ORIGINATION FORM

Proposed Revisions to a Standard Plans Index (Please provide all information — Incomplete forms will be returned)

Index Number: 455-020

Index Title: 20" Square Prestressed Concrete Pile

LAST REVISION	DESCRIPTION:	FDOT	FY 2020-21 STANDARD PLANS	20" SQUARE PRESTRESSED CONCRETE PILE	INDEX	SHEET
01/01/12					455-020	1 of 1

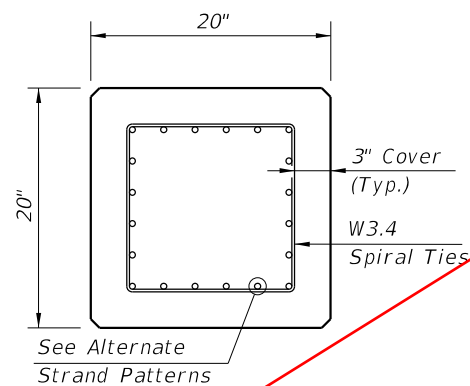
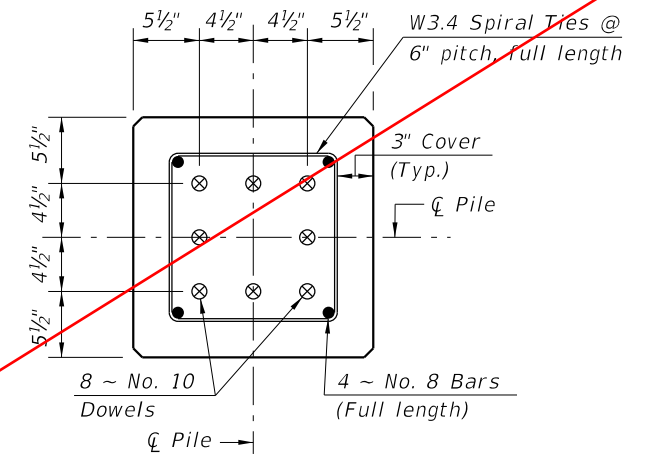
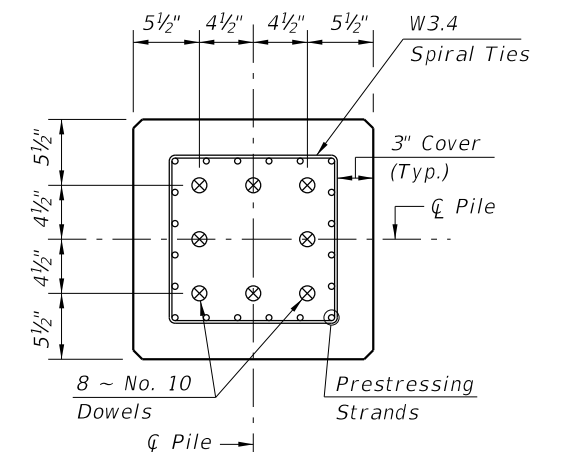
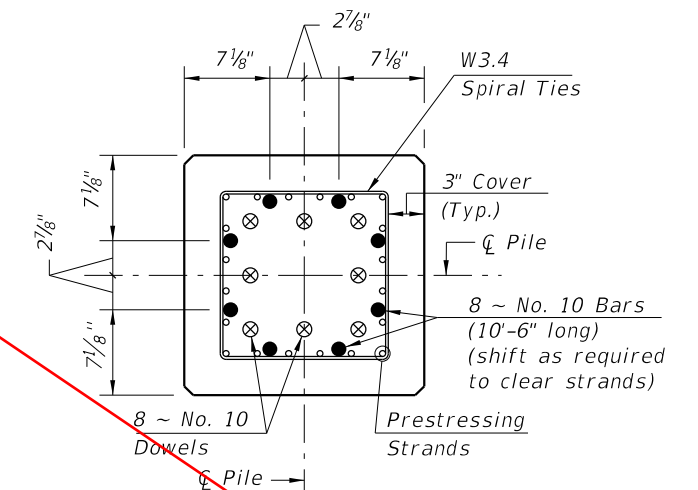
Delete Index (Sheet 1 of 1)

Uncommon size, not used; therefore the forms are not readily available should it be called for. Costs more than a 24" pile.

DELETE ENTIRE INDEX** See Note 4 on Index 455-002
